RE: Response to WDFW Comments on RU-25-00004 Thomas
Parcel186635, Kittitas County, Washington
SWC Job #24-117

This letter is in response to the January 7, 2026 letter from Cassandra Weeks of WDFW to you regarding the Thomas property Reasonable Use Exception application for 4421 Kachess Lake Road (Parcel186635) in the Easton area of unincorporated Kittitas County, Washington (the "site").

Above: Proposed site plan with added buffer as mitigation for buffer impacts.

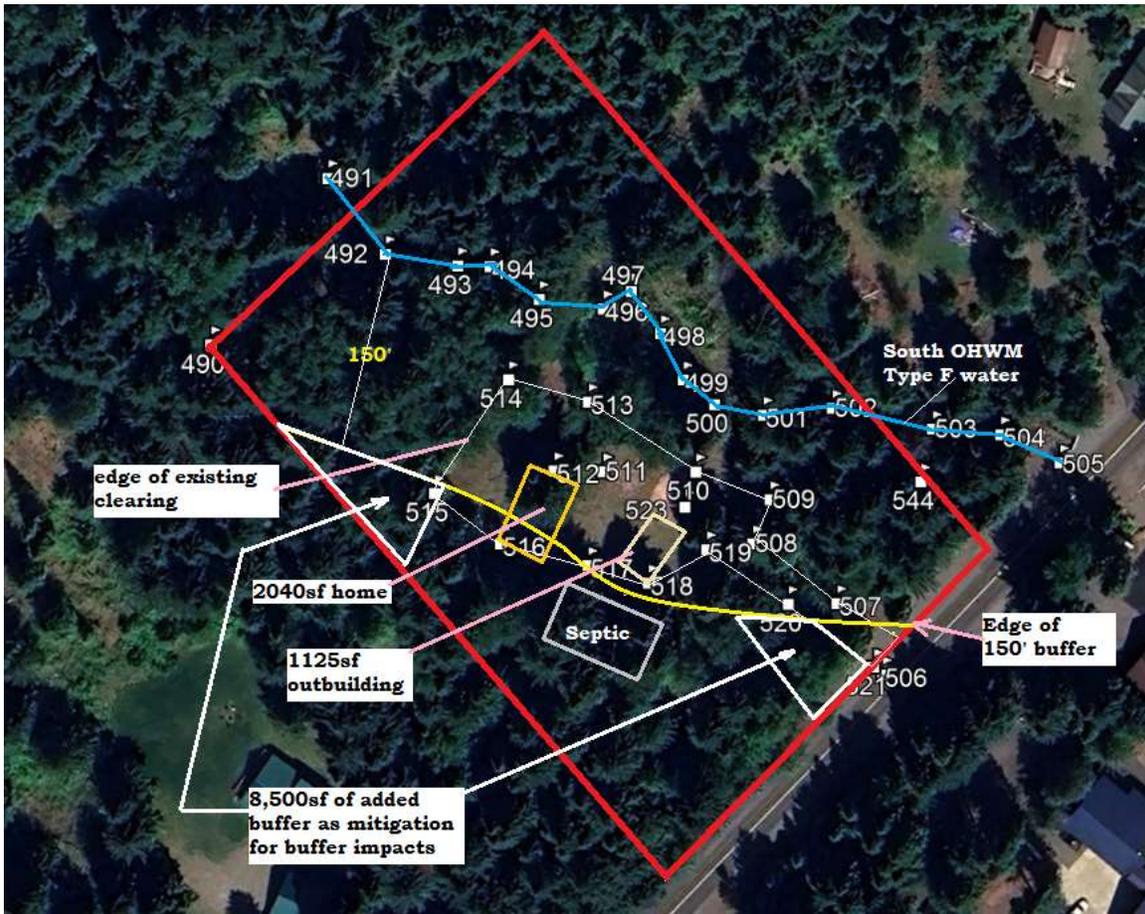
The letter stated that WDFW did not see a plan showing where the buffer will be added. This was included in our July 15, 2025 CAR on page 15 clearly showing the added areas. We have included that image below from the originally submitted CAR. Since they did not review our proposed added buffer areas they were unaware we were showing the added buffer areas as mitigation for any functional buffer impacts to the Type F stream.

At this point we do not believe a “mitigation plan” with plantings is required to mitigate any buffer function impacts that are not being addressed by the added forested buffer areas for this project. The proposed buffer enhancement will result in no net loss of buffer function to the stream, will increase tree cover to the Type F stream, and utilizes best available science.
